Downshift State Diagram Issues

G. Zimmerman

CME Consulting/

Figure 98D-1—Downshift state diagram

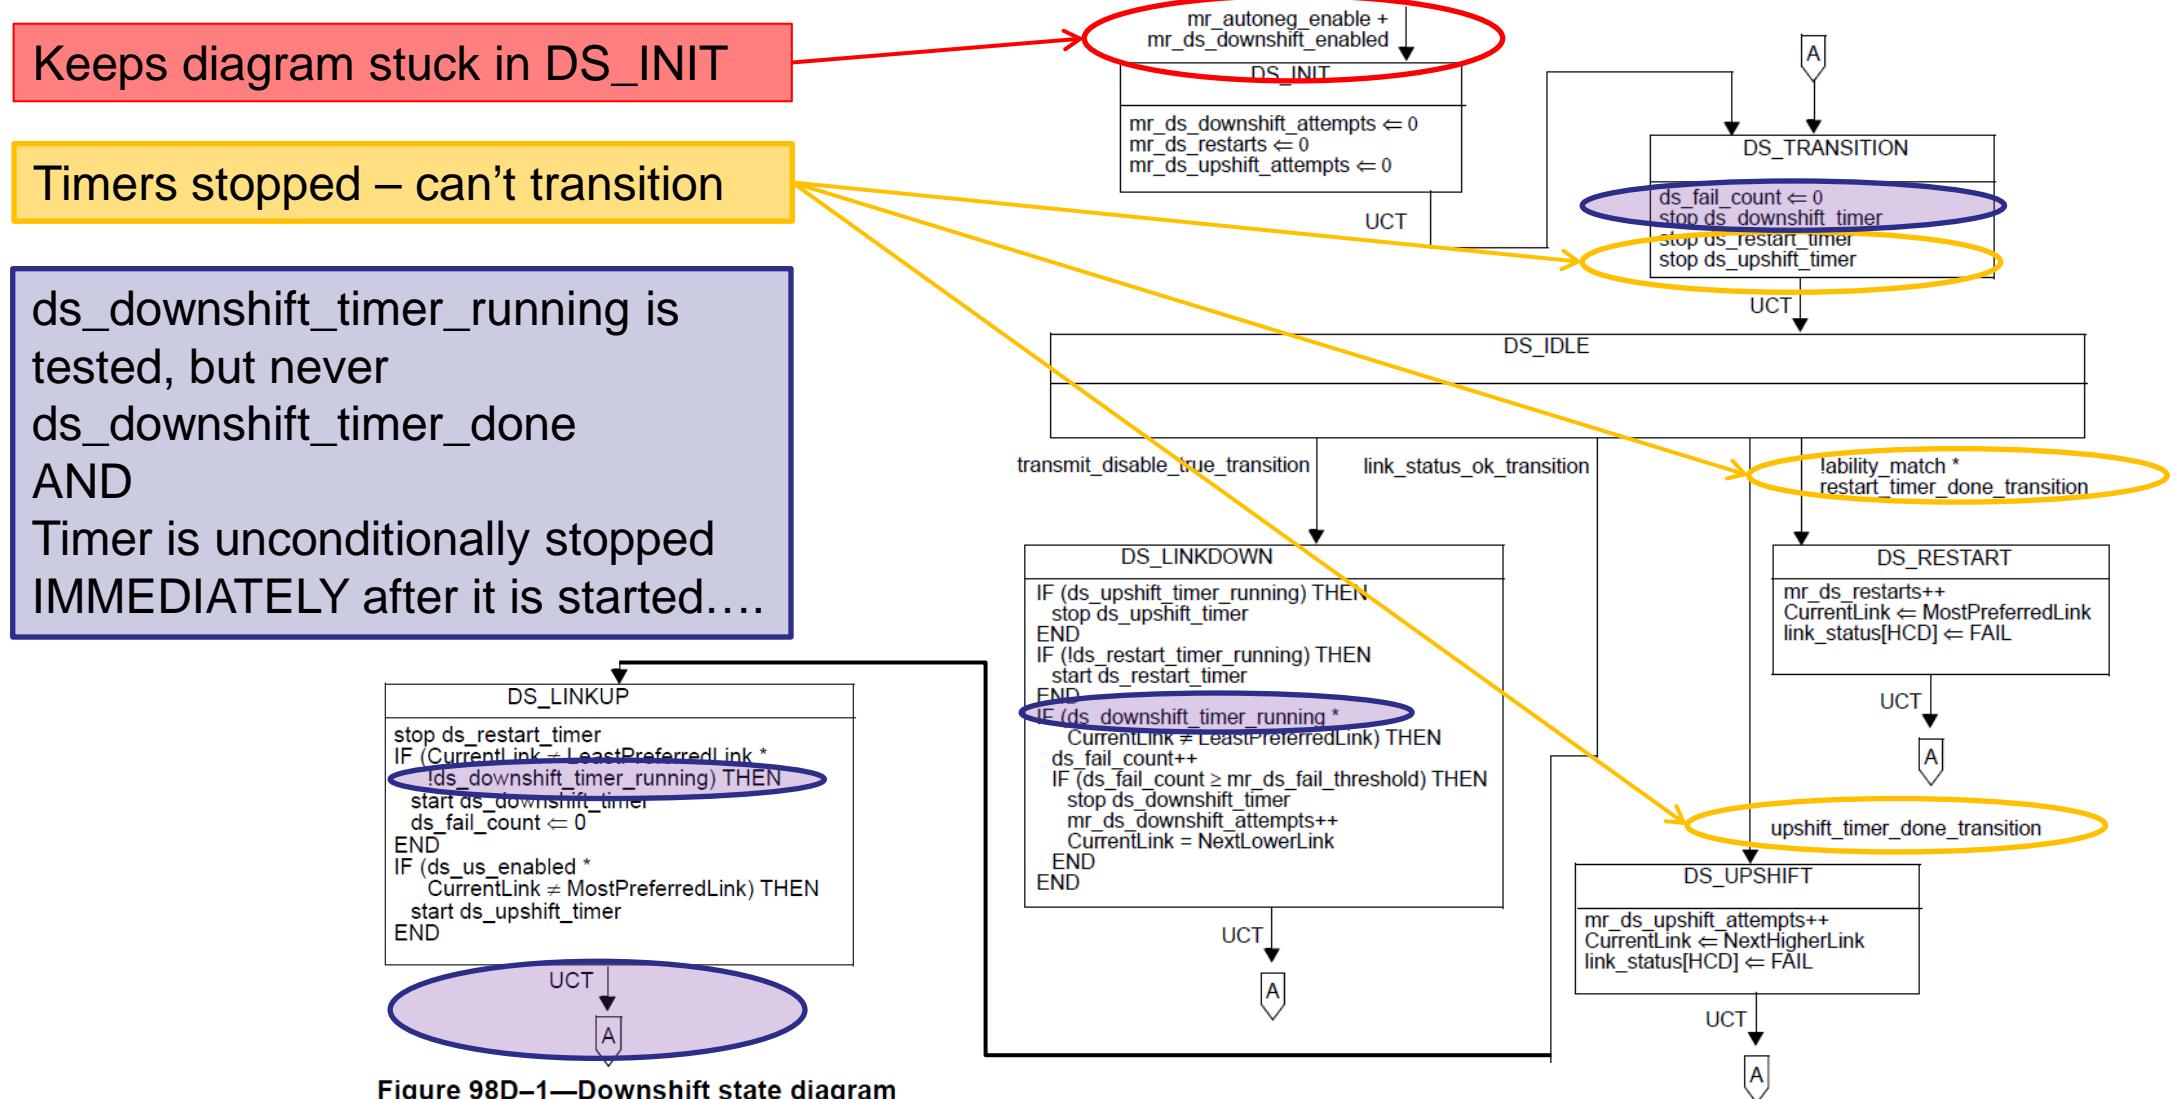
- State diagram in 98D.2 has functional issues, at least:
 - Stuck in DS_INIT state
 - Open ended transition into DS_INIT on mr_autoneg_enable & mr_ds_downshift_enabled
 - Can never go to DS_UPSHIFT
 - upshift_timer is stopped before waiting for a transition...
 - Can never go to DS_RESTART
 - restart_timer is stopped before waiting for a transition...
 - ds_downshift_timer doesn't work – stopped right after started
 - ds_downshift_timer_done is never tested, perhaps “_running” might be a function of !done.
- Could be more....
